11.12 2019

## Consultation response to Wheelabrator PEIR reports

Strava 'heat map' showing recorded cycle trips. The white hot routes are the most heavily used.

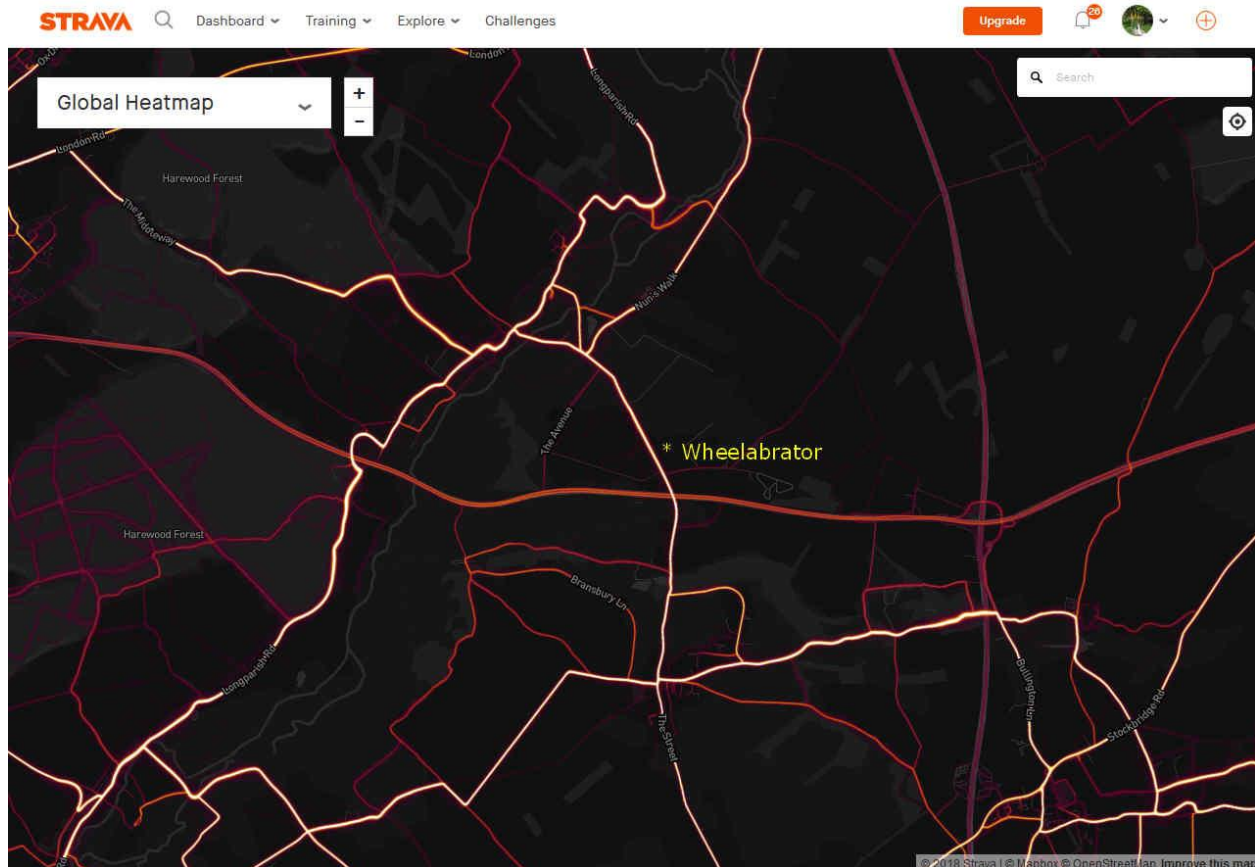
However, the premise that there is little cycle traffic is incorrect. The popular GPS-based cycling app Strava (<https://www.strava.com/heatmap>) has on-line 'heat maps' showing the routes of actual recorded cycle rides and the heat map for this area (see above) shows that The Street is indeed a popular cycle route – for the reason that it provides one of the few sparsely-spread opportunities for cyclists to cross the A303.

The principal safety risk to cyclists is probably from HGVs exiting the Wheelabrator site and turning left before turning left again to get onto the westbound A303; left-turning HGVs are well-known to be a principal cause of cycling fatalities in the UK. However, neither this nor any other risks appear to have been evaluated and the section on Accidents and Road Safety (paras. 6.144, 6.145, 6.146) make no reference at all to accidents involving cyclists. Paragraph 6.148 also concludes that 'amenity and ambience for non-motorised users is likely to worsen but with limited users per day (low sensitivity) the overall effect is likely to be minor adverse at worst, which results in a temporary negligible effect; this is not considered significant'. Paragraph 6.155 uses similar words in coming to the same conclusion with respect to fear and intimidation of non-motorised road users. We doubt if the many cyclists that use the road past the site would agree with either conclusion, especially with the implied lack of intimidation in sharing The Street with HGVs.
